Access Compliance Report Public Rights-of-Way (Curb Ramps)

Main Street: VENTADA_ST Cross Street: BALIZA_RD Location: W

ADA ID: RPRK211129134507 Ramp Type: Type 4 - Parallel Initial Pass/Fail: Fail Overall Compliance: No Severity Score: 2

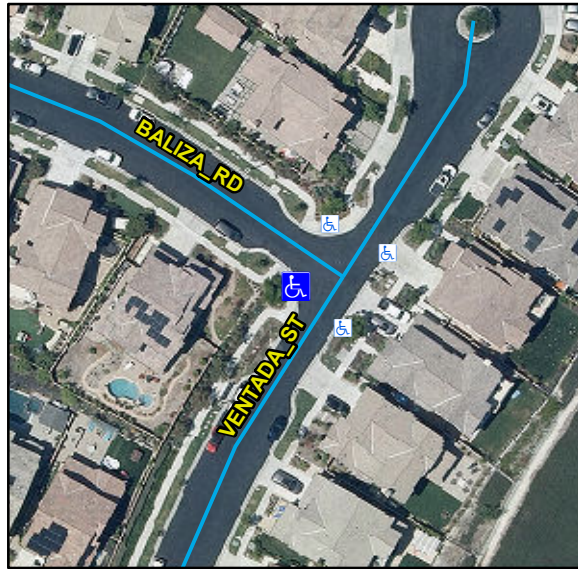
Compliance	Description	Data	Compliance	Description	Data
N/A	Ramp Length LT (in)	78	N/A	Ramp Length RT (in)	89
Yes	Ramp Width LT (in)	53	Yes	Ramp Width RT (in)	53
Yes	Ramp Run Slope LT (%)	6.8	Yes	Ramp Run Slope RT (%)	6
No	Ramp Cross Slope LT (%)	2.2	Yes	Ramp Cross Slope RT (%)	0
N/A	Landing Present	N/A	N/A	DWS Provided	N/A
N/A	Landing Length (in)	N/A	N/A	DWS Contrast	N/A
N/A	Landing Width (in)	N/A	N/A	DWS Length (in)	N/A
N/A	Landing Run Slope (%)	N/A	N/A	DWS Full Width	N/A
N/A	Landing Cross Slope (%)	N/A		DWS Offset Type	N/A
N/A	Landing Movement Obstructed?	N/A	N/A	DWS Offset Left (in)	N/A
	Landing Movement Type	N/A	N/A	DWS Offset Right (in)	N/A
N/A	Landing Shared	N/A			
N/A	Clear Space	Yes			
N/A	Clear Space To Crosswalk (in)	N/A			
N/A	Marked Crosswalk 1	No	N/A	Marked Crosswalk 2	No
	Crossing 1 Direction	SE		Crossing 2 Direction	NE
	Marked Crosswalk 1 Width (in)	N/A		Marked Crosswalk 2 Width (in)	N/A
N/A	Ramp Inside Crosswalk 1	N/A	N/A	Ramp Inside Crosswalk 2	N/A

Remove & Replace Curb Ramp With Two New Directional Ramps or Equivalent.

R304.5.3, STD 1115
